Prairie Island Nuclear Generating Plant Unit 2  
Docket 50-306  
License No. DPR-60

Response to Request for Additional Information on Relief No. 21 for Unit 2 Third  
10-Year Interval Inservice Inspection Program

**ENCLOSURE 1**  
**RESPONSE TO REQUEST FOR ADDITIONAL INFORMATION**  
**PRAIRIE ISLAND NUCLEAR GENERATING PLANT**

**Request for Relief No. 21, Items 1 through 4, Examination Category B-D, Item B3.90, Full Penetration Welded Nozzles in Vessels**

Figure 1: Detail of header restraint

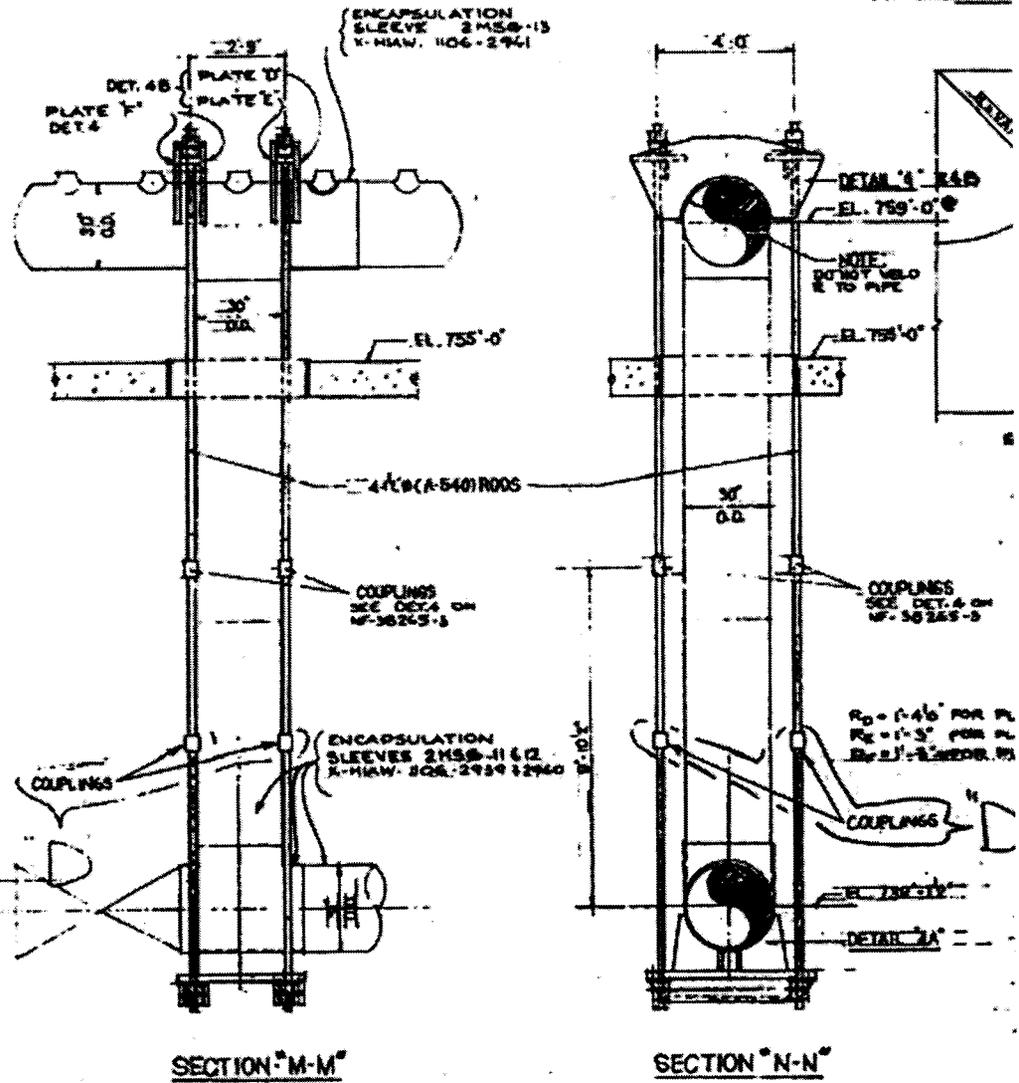
- b) In the licensee's submittal, the cross-sectional sketch of the access limitation caused by the outside surface geometry of the flange is adequately depicted. Page 4 of 4 of the supplemental report also states scans were limited by interference from a piping support, and photographs of the weld are shown. However, these photographs and brief comments on the supplemental report do not adequately describe the limitation to scans caused by support interference. Please describe the support, and how it impacts the ASME Code-required scans for this weld.

- b) The support is H-4, which is on 2-ISI-47B (Header Restraint #8). This is a very large restraint that bolts through two floor elevations and is saddled on both sides of the weld to be examined. This restraint limits all four scan directions. Figure 1 below provides detail of the header restraint.
